PG&E Letter DCL-03-121

Docket No. 50-323, OL-DPR-82  
Diablo Canyon Unit 2  
PG&E Response to NRC Questions on 2R11 Steam Generator Tube Inspections

**PG&E Response to NRC Questions on Unit 2 Eleventh Refueling Outage  
Steam Generator Tube Inspection 90-Day Report**

Figure 2-1

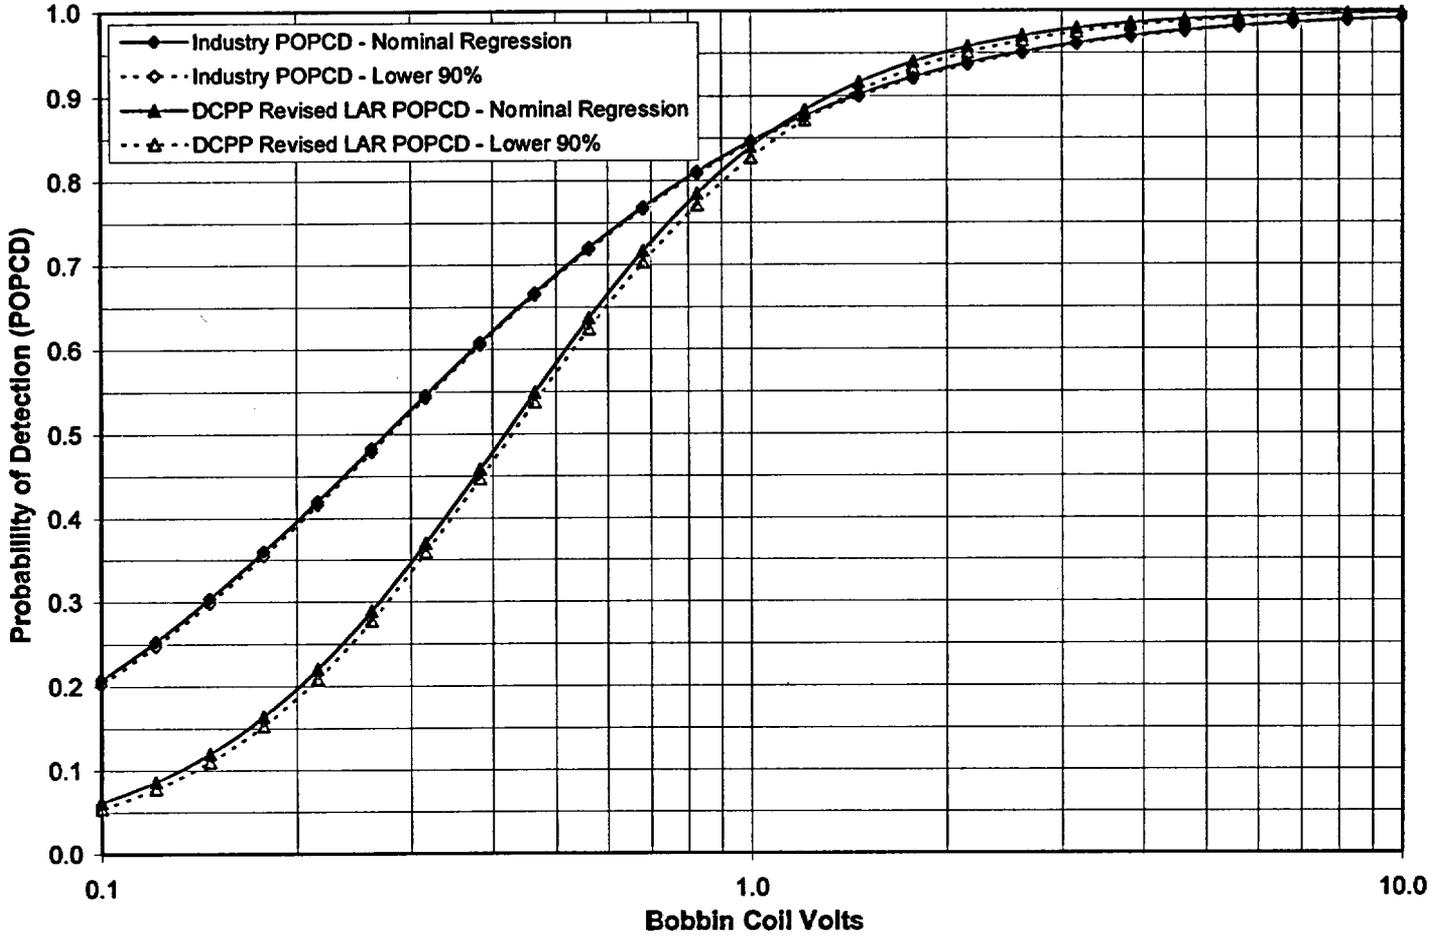
*"With respect to the POPCD evaluation, the POPCD function at each outage should only include data that was available at that time. A generic POPCD which includes data from other plants (at that time) may be used consistent with the methodology for determining when a generic POPCD curve should be used (versus a plant-specific POPCD)."*

As discussed with the NRC in the April 15, 2003, meeting, application of a plant-specific POPCD requires satisfaction of minimum data requirements for which preliminary guidelines are described below. If a plant does not meet the minimum data requirements, the industry POPCD distribution (ARC database Addenda POPCD) must be applied unless it is shown that the plant-specific POPCD distribution for ARC analyses yields a uniformly lower POD above 1.0 V and has a POD less than 0.35 at 0.1 V. The lower bound POD above 1.0 V assures a conservative plant-specific POD for significant ARC indications. The 0.35 value at 0.1 V represents an upper bound to existing POD distributions for axial ODSCC at tube support plate (TSP) intersections and assures a representative value for new undetected, low voltage indications.

PG&E has reviewed these preliminary guidelines with respect to benchmarking applications in response to the NRC request. After the 2R11 inspections for DCPD Units 1 and 2 the three minimum data requirement criteria are satisfied, and, therefore, have an adequate database to define a plant-specific POPCD for Unit 2 Cycle 12. However, for prior cycle benchmarking, DCPD Units 1 and 2 do not satisfy all three minimum data requirement criteria, mainly due to not satisfying the third criteria regarding a minimum of 20 detected and RPC confirmed indications above 2.0 V. As shown in Figure 2-1, which compares the industry POPCD with the DCPD-specific POPCD (revised POPCD from Figure 1 of PG&E Letter DCL-03-109, "Supplemental Information to Support License Amendment Request 03-10, 'Revised Steam Generator Voltage-Based Repair Criteria Probability of Detection Method for Diablo Canyon Unit 2 Cycle 12,'" dated September 3, 2003), the DCPD-specific POPCD yields a POD less than 0.35 at 0.1 V, but yields a uniformly higher POD above 1.0 V. As a result, the industry POPCD must be used for prior cycle benchmarking. Below, Table 2-1 provides the industry POPCD correlations utilized in the benchmarking calculations. The industry POPCD curve is from Table 1 of PG&E Letter No. DCL-03-078, "License Amendment Request 03-10, 'Revised Steam Generator Voltage-Based Repair Criteria Probability of Detection Method for Diablo Canyon Unit 2 Cycle 12,'" dated June 26, 2003.

Figure 3-1

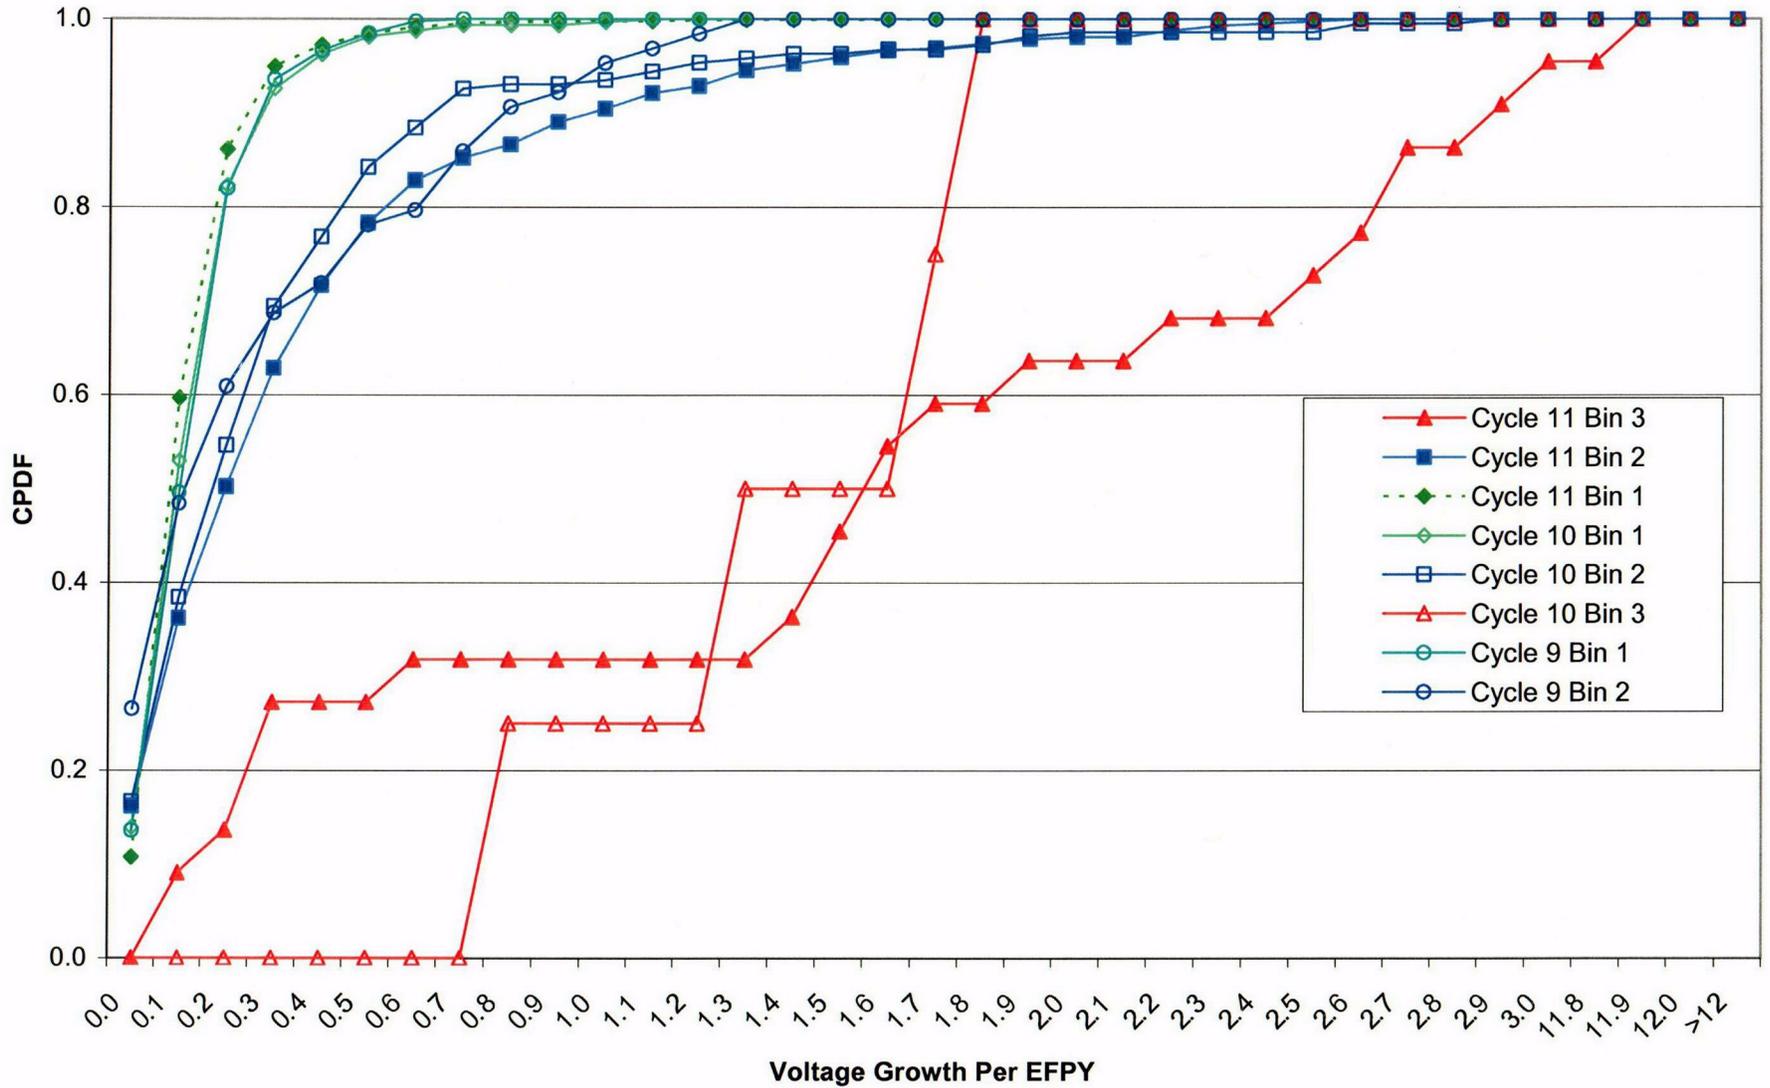
*"With respect to the voltage dependent growth distribution, the staff notes that for the cycle 12 operational assessment, the middle voltage growth bin was increased by 10% during this assessment. Similar adjustments to the data for each cycle should be considered in this assessment if the data supports such an increase. In addition, the method by which this value is determined should be discussed. This adjustment was based, in part, on a comparison of Figures 3-22 and Figures 3-28. Please combine these two figures on one graph since the staff could not readily discern the 10% increase in this bin versus increases in other bins. Additional justification for increasing the middle bin by 10% was based on the data plotted in Figure 3-29. Please provide a similar assessment with the voltage growth data divided into voltage bins since Figure 3-29 shows an increase of 10% in growth for all indications (i.e., address whether the increase in growth in the middle bin is consistent with the overall increase in voltage growth)."*

As requested, Figure 3-1 below combines Figures 3-22 and 3-28, and provides the Cycles 10 and 11 voltage dependent growth (VDG) data divided into the Cycle 11 Bins (0-0.59, 0.59-1.66, >1.66 volts per effective full power years (V/EFPY)) on a single graph. Also included is the Cycle 9 data for Bins 1 and 2 for comparison as well (No Bin 3 data was present in Cycle 9). Table 3-1 depicts the average Bin 2 growth rates for each SG for Cycles 9, 10, and 11, as well as the average of all four SGs, using the Cycle 11 VDG breakpoints. The increase in average growth rate for all SGs in Bin 2 was 19 percent from Cycles 9 to 10 and 21 percent from Cycles 10 to 11. From Figure 3-1, it is seen that the cumulative distributions for Bin 2 (and Bin 1) remain relatively constant with minor oscillations in either direction over the last three cycles, but do not indicate a consistently increasing growth rate. Below about 0.9 cumulative probability distribution function (CPDF), Cycle 9 Bin 2 growth is comparable to Cycle 11 and larger than Cycle 10. Only 64 data points were present in Cycle 9, compared to 216 data points in Cycle 10 and 420 in Cycle 11. The Cycle 11 data is, therefore, considered a more mature population than Cycle 10, and as such is more representative of the VDG that is occurring to Bin 2 indications. As the population continues to mature, the Bin 2 growth curve will continue to shift towards the left on the CPDF curve (as additional slower growing data points are added) and then maintain relative consistency from cycle to cycle. The VDG data from European SGs that was presented to the NRC staff during the March 4, 2003 meeting supports the mature growth phenomenon of a large population of indications. Even though the Bin 2 data from Cycle 11 suggests a similarly mature population and the Bin 2 growth rate is not expected to significantly increase or decrease over Cycle 12, the Cycle 12 OA used a 10 percent increase to the Cycle 11 Bin 2 growth data.

In terms of the increase in average growth over the entire population as depicted in Figure 3-29 of the 90-day report, the actual increase from Cycle 10 to Cycle 11 was 13 percent. As discussed above, the 10 percent value was deemed as a conservative adjustment to an already representative population of indications that resided in Bin 2 at beginning of cycle (BOC) 11.

Figure 4-1

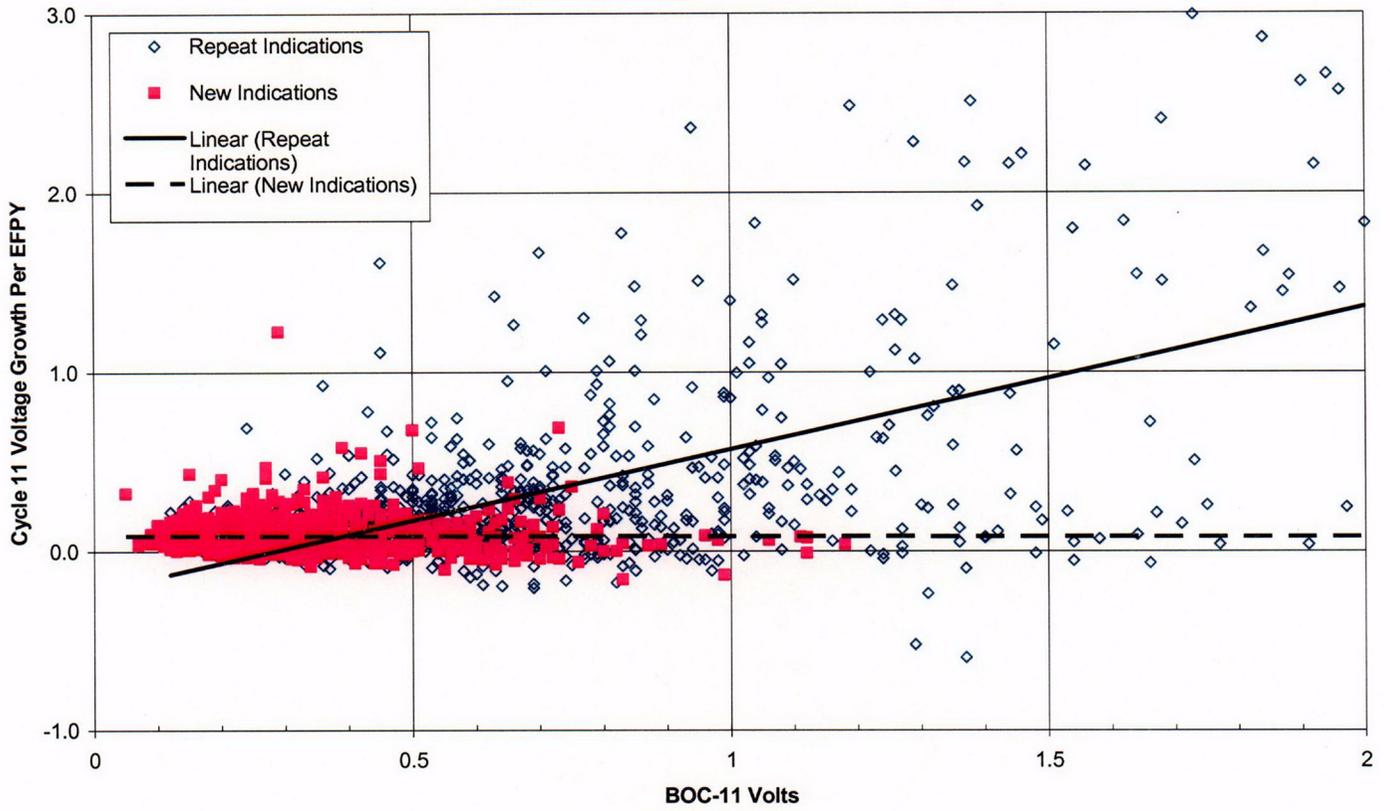
*"The staff notes that the process of re-evaluating the data from the previous outage in determining the growth rate distribution result in the inclusion of many low growth rate indications. This reevaluation is an accepted practice; however, it may result in forcing voltage calls for eddy current signals which may not really represent the presence of a flaw resulting in a non-conservative growth rate distribution (since the frequency of the larger voltage growth rates is reduced). As a result, the growth rates for these indications may actually be higher (i.e., since the indications may have initiated during the course of the cycle rather than truly being present for the whole cycle). Your benchmark assessment should consider the effect of removing these indications from the growth rate distribution to determine if this re-evaluation process is resulting in non-conservative projections. An assessment of whether exclusion of this data affects the breakpoints in the VDG rate distribution should also be considered. The staff notes that you have observed that new indications are not exhibiting as much voltage dependent growth as repeat indications. Your assessment should address whether this could be a result of the above effect."*

The Cycle 11 growth data for all SGs (previously provided in Figures 3-10 to 3-13 of the 2R11 90-day report) is consolidated on a single graph in Figure 4-1 below, trending new and repeat indication voltage dependent growth rates. The figure clearly depicts that voltage dependent growth is primarily occurring in repeat indications. This is the expected condition due to the exponential dependence of volts on depth. The low voltages of the new indications suggest that they are shallow so the exponential effect on growth is minimal for them, compared to the higher voltage repeat indications that are likely deeper. In Figure 4-2 below, new and repeat cumulative growth curves were plotted along with the Cycle 11 voltage independent growth curve. This figure shows that the repeat indications do in fact grow faster than new indications. The graph also shows the independent curve does not bound the repeat growth, and as such, if the

**Figure 5-1: Comparison of tri-linear fit of the growth data  
to a 3<sup>rd</sup> order polynomial fit**

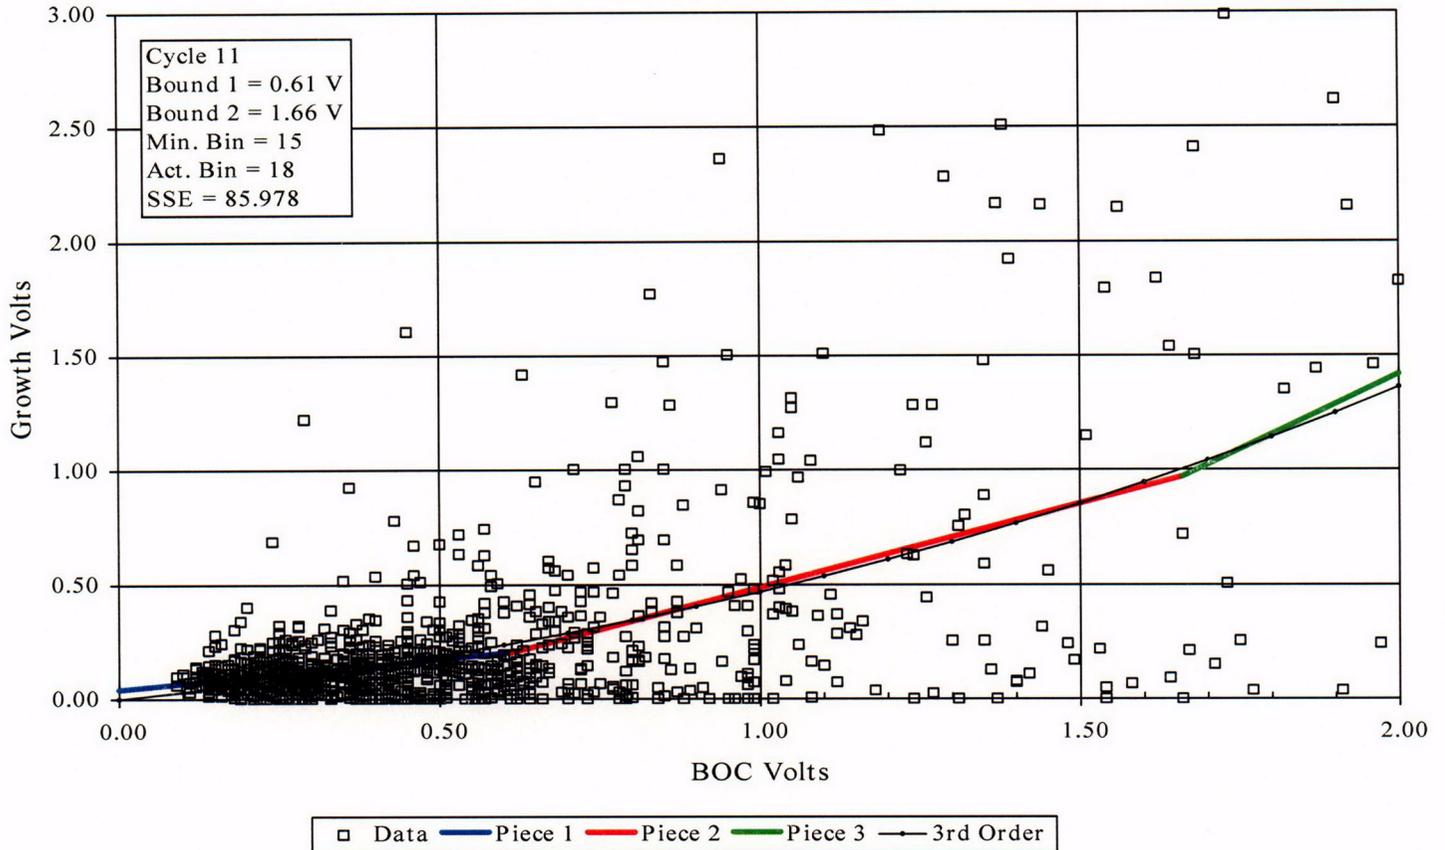
*"With respect to the breakpoints in the VDG rate curves, discuss any physical insights of why the growth rates would change as a function of initial voltage amplitude (or more specifically what is occurring below 0.59 volts that is different from what is occurring between 0.59 and 1.66 volts). Discuss whether you have any insights of whether these breakpoints would change with time or would be well defined if a larger dataset were evaluated."*

Bobbin coil voltage increases exponentially with depth and again exponentially with throughwall crack length. Consequently, for a given incremental growth in depth, the associated incremental increase in voltage will tend to increase exponentially with BOC depth and associated BOC volts. For low voltages, the exponential effect can be approximated as a linear effect and voltage growth is not a significant function of BOC volts. This concept is recognized in GL 95-05, which notes that an assessment is recommended to determine the voltage above which voltage growth becomes a significant function of BOC volts. Below about 0.59 V, ARC historical data have shown negligible VDG as also seen in the DCPD 2R11 data of Figure 5-1. Between about 0.59 V and 1.66 V, the DCPD growth data show a growth trend increasing with BOC volts, which reflects the deeper indications at the higher voltages. It can be reasonably expected that the VDG breakpoints will change moderately with time as the number of higher voltage indications increases. As more slow growing indications progress to higher voltages (population matures), it may be expected that the frequency of large growth rates in the VDG bins will decrease. This behavior is seen in European voltage growth data based on large populations of high voltage indications. The European data show incremental increases in growth with increases in BOC voltage, which tends to indicate that the VDG breakpoints become well defined with large datasets.

A piecewise linear fit to the data provides an advantage to a straight linear fit in that it provides an approximation to a polynomial or exponential relation. This can be seen by examining the comparison provided on Figure 5-1. In Figure 5-1 the distribution of growth as a function of initial voltage was fit to a third order polynomial in order to include the zero growth values in the regression. The dependence is not strong nonlinear. The index of determination,  $R^2$ , for a 1<sup>st</sup> order fit to the data is almost 31 percent while the value for a 3<sup>rd</sup> order polynomial is a little more than 32 percent. This indicates that the use of a polynomial does not result in a large increase in explaining the variance of the prediction by adding two orders of complexity to the model. However, it is apparent that accounting for the potential increase in the dependency by performing a trilinear fit is worthwhile in that predicted future indications will have larger amplitudes in greater proportion.

Figure 10-1

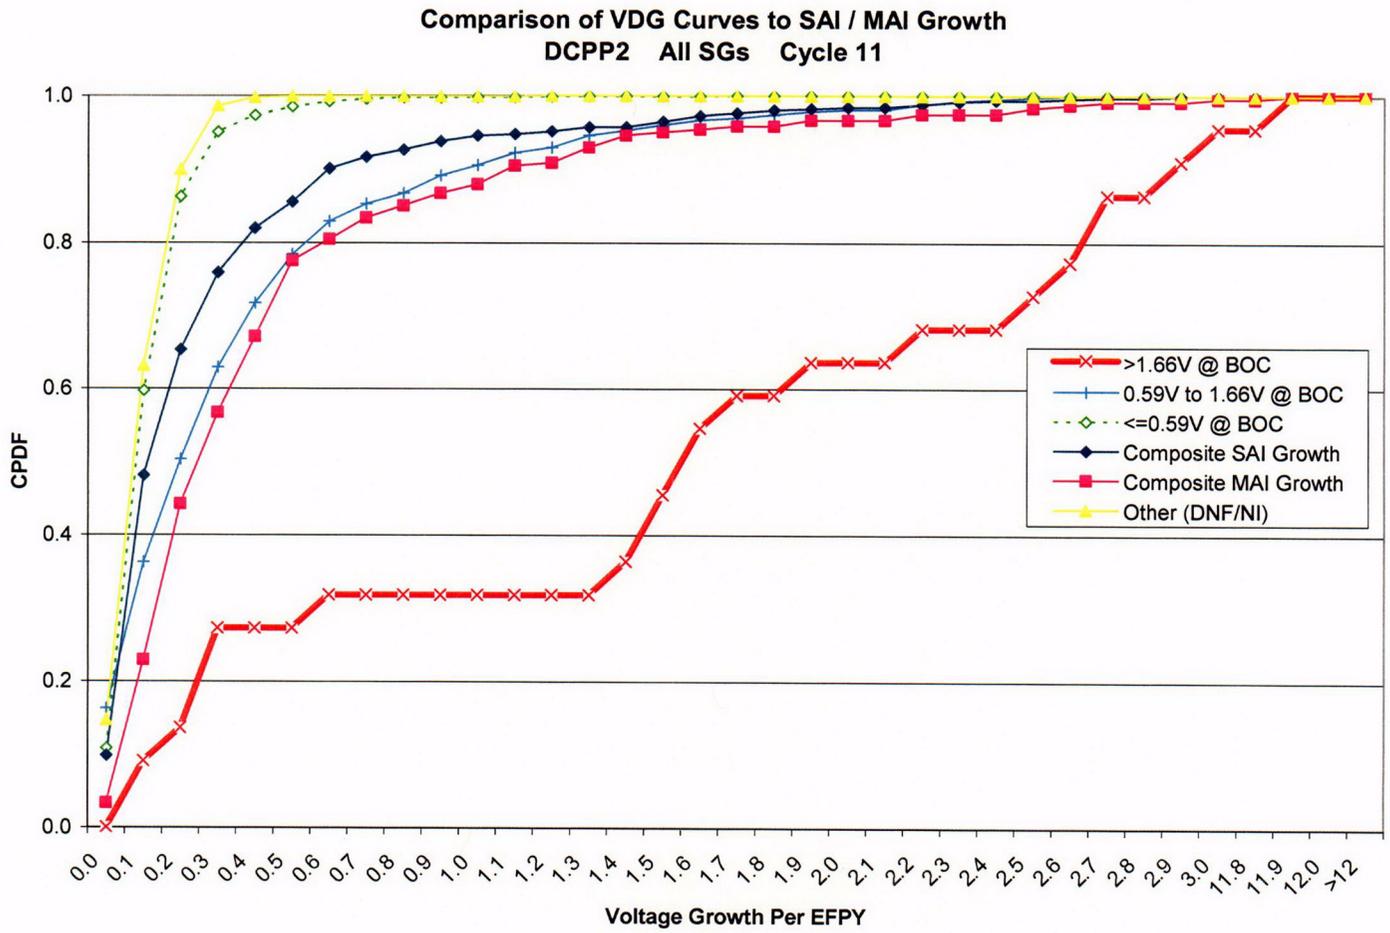
*"Table 3-4 of Enclosure 4 to your June 23, 2003 letter, lists the largest voltage growth rates observed during cycle 11. All of these indications were single axial indications. Please discuss whether the growth rate distribution for single axial indications is different than that for multiple axial indications and whether separate growth rate distributions should be used for assessing these data sets. If so, please discuss whether additional rotating probe testing would need to be performed to determine which indications are single axial indications and which ones are multiple axial indications (or volumetric)."*

The Cycle 11 growth rate data was segregated into categories for single and multiple confirmed axial indications. A total of 750 DOS were confirmed during the Plus Point inspections performed at 2R11 (240 multiple axial indications (MAIs) and 510 SAI). The remaining 1103 DOS were either not Plus Point inspected (NI) or did not confirm (DNF) by Plus Point as degradation. The voltage growth for these indications is depicted graphically in Figure 10-1 below. As expected, the voltage growth for the TSP intersections affected by MAIs is higher than that for intersections that are affected by SAIs. The reason for this

affect is that the bobbin coil voltage is an "integral" of all the flaws present at the TSP, so a change in depth of any of the secondary flaws present or the development of an additional flaw during a cycle would have a higher resultant growth rate compared to a primary SAI growing only in depth during the cycle. The DNF/NI curve in Figure 10-1 contains the indications that were not Plus Point inspected or did not confirm with Plus Point. It is important to note that if more of these indications had been inspected with Plus Point, the result would have been to "pull" the SAI and MAI growth curves further to the left, since a large number (about 90 percent of 1103) of lower growth values would be added to those curves based on the overall DOS confirmation of about 90 percent. Therefore, additional Plus Point inspections are not warranted in an effort to determine which indications are SAIs and which ones are MAIs. Since the growth data show the expected trend that MAI growth is moderately larger than SAI growth and that the non-Plus Point inspected population could further reduce the differences, it is further concluded that there is no need to separate MAIs and SAIs in the growth distributions used for OA analyses.
